# 8XC196KD AUTOMOTIVE APPLICATION SPECIFICATION UPDATE

Release Date: May, 1998  
Order Number: 272839-003

**016. Page 5-26**

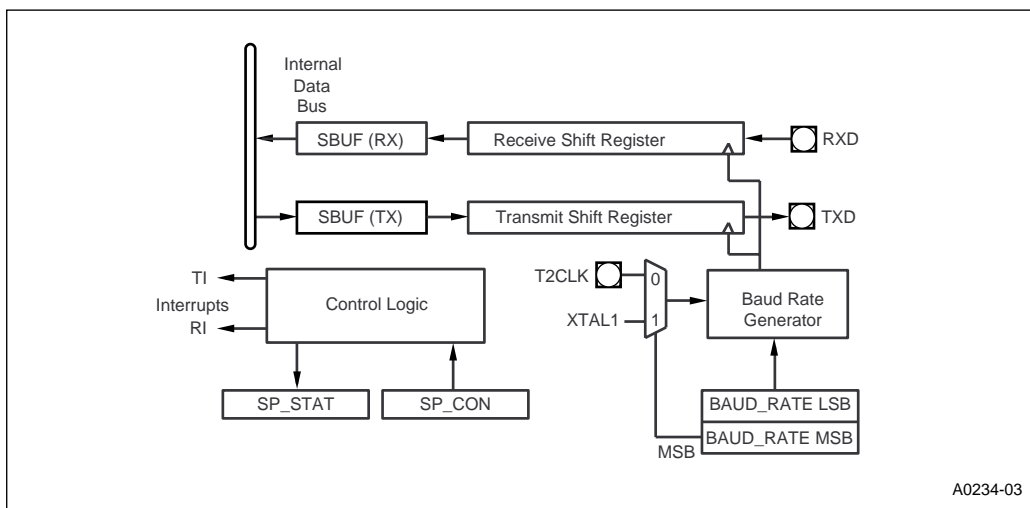
**ITEM:** In Table 5-19, the PTSCON should equal **2Ah** instead of 6Ah.

**018. Page 7-1**

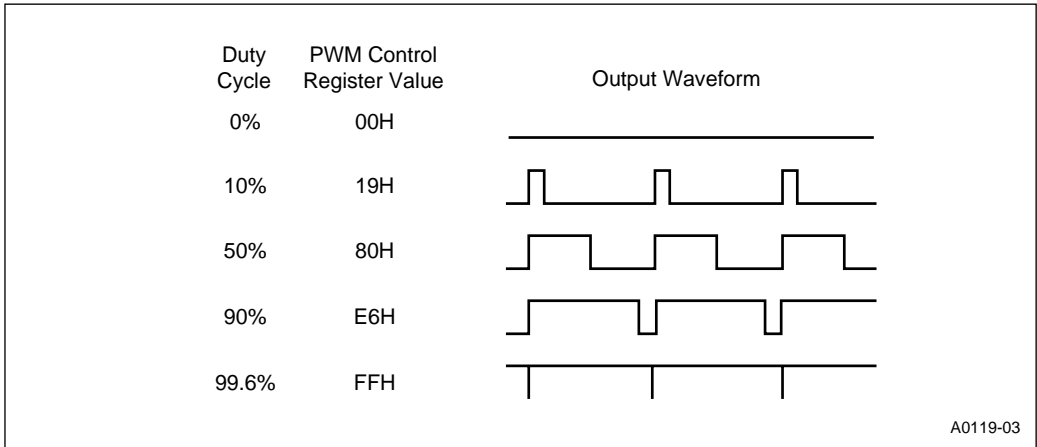
**ITEM:** The following block diagram will be included in future manuals.

The following figure replaces Figure 10-2:

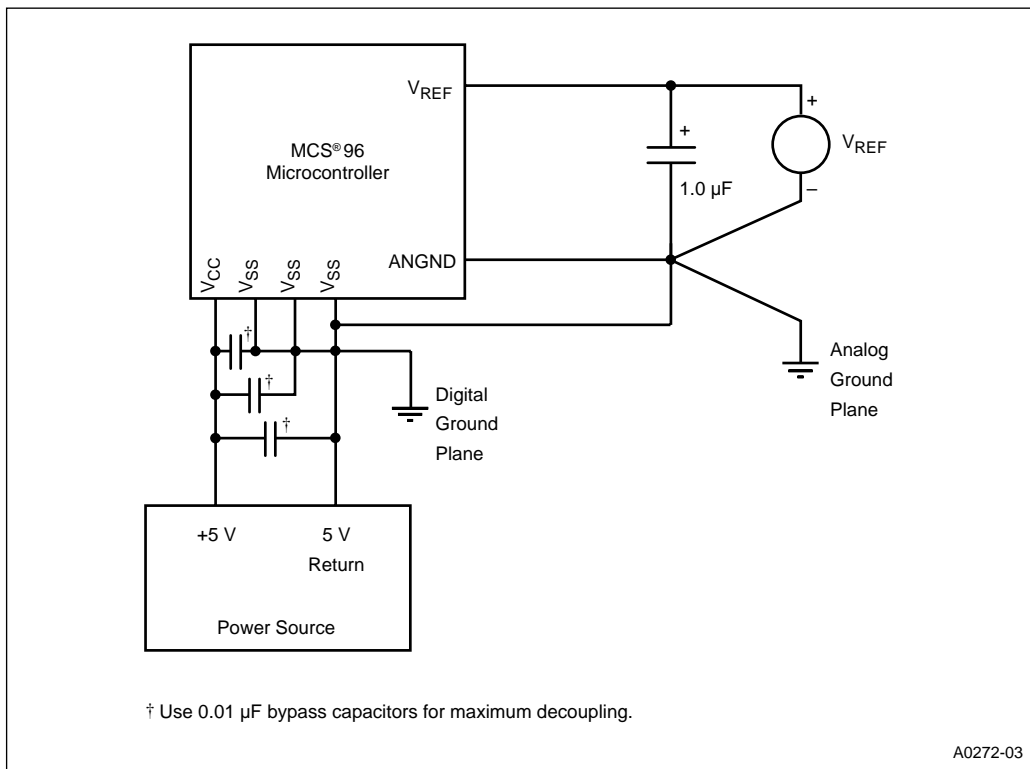
**ITEM:** On page 10-2, add the following sentences to the second paragraph after the first sentence: ‘Since the value written to the control register is buffered, you can write a new 8-bit value to PWMx\_CONTROL before the counter overflows. The new value is used during the next period of PWMx.’

Figure 11-6. External Clock Drive

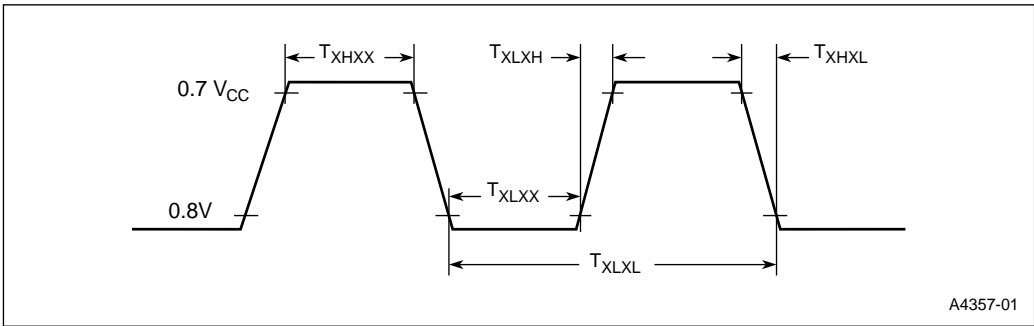
**ITEM:** In Figure 11-6, the timing diagram incorrectly represents the  $T_{x|xl}$  and  $T_{x|xl}$  timing specifications. The timing diagram below replaces Figure 11-6.

Figure 11-8. Reset Pin Internal Circuit

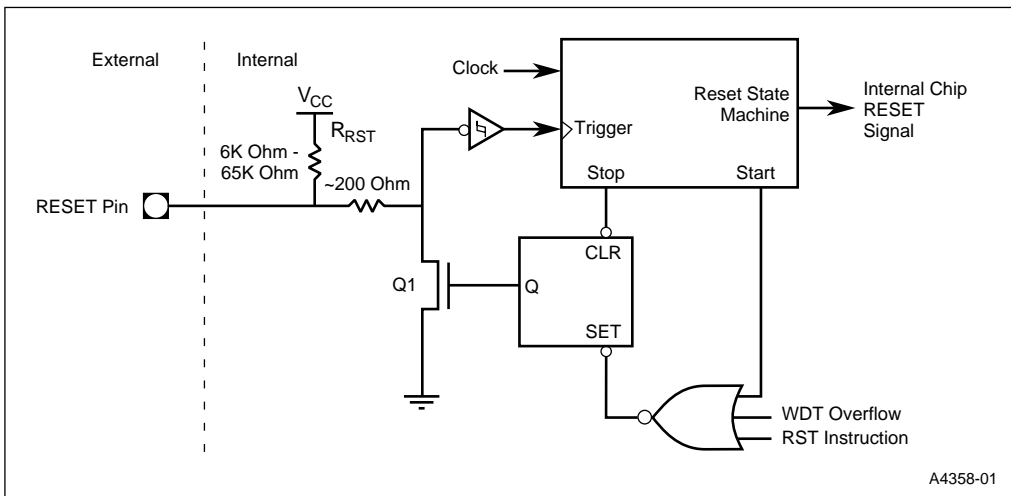
**ITEM:** Figure 11-8 shows the reset pin internal circuit. However, there are a couple of mistakes; the following figure shows the corrected version. The **inverter** at the Reset State Machines Trigger input and the **OR gate** at the SET input of the latch are the corrections to this figure.
